SUBJECT: Power Shield Tap Block Solder Joints
10CFR Part 21 Report

NOTIFICATION BY: ABB Inc.
Allentown site
7036 Snowdrift Road
Allentown, PA 18106
Dennis Haring
Quality Assurance

Power Shield Tap Block Solder Joints
10CFR Part 21 Report
Attachment A
November 20, 2002

Photo #3

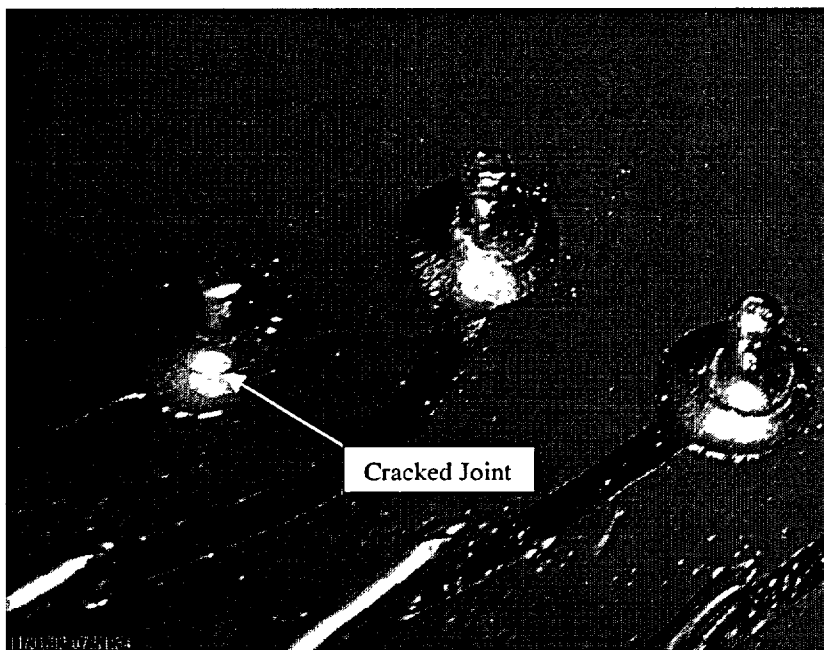
Photo #3 shows cracked solder connections on three tap block pins (underneath tap block).

1. Inspect the solder connections on the tap block pins on the Short-Time / Ground And Long-Time / Inst printed circuit assemblies. Martin Marietta, IPC 610-A-610 Class 3 or the photographs provided by ABB should be used when inspecting these solder connections. All cracked or defective solder connections found, should be repaired by qualified personnel familiar with electronic circuit board repair. ABB Inc. recommends the following method be used:
 - 1a. The defective solder connection must be completely desoldered by using a good quality desoldering tool or solder wick. Care must be used when desoldering the joint as excessive heat will cause the printed circuit pad to

- 1b. All flux residue and poly spray must be removed from the connection area. ABB Inc. recommends that Micro Care MCC Pro Clean or a suitable substitute be used.
- 1c. A tap pin **must** be connected in to the associated tap block position when resoldering the connection. A 60/40 rosin core solder should be used. The soldering iron temperature should be 700 to 800 degrees Fahrenheit. Upon completion, the soldered connection should be cleaned of all flux residue. Personnel resoldering connections should have electronic repair and soldering skills and follow established ESD practices.

Photo #4

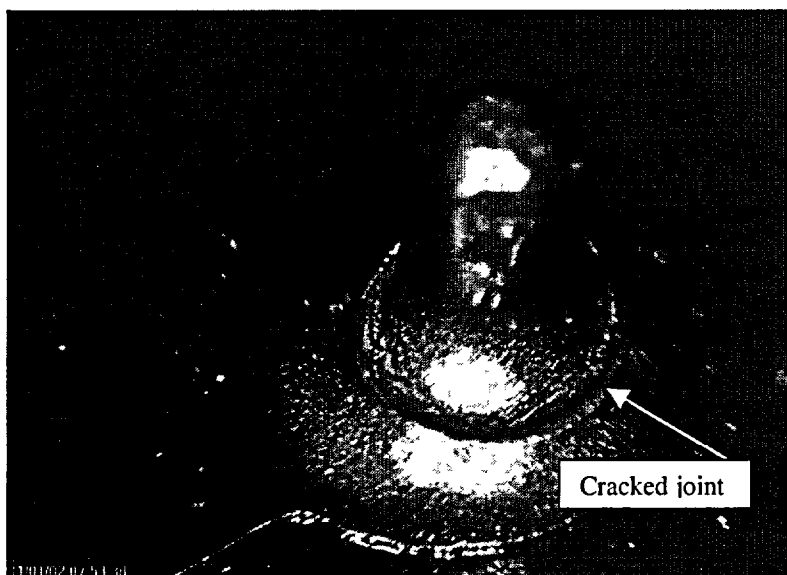
Photo #4 shows a tap block pin solder joint with a 360 degree crack.
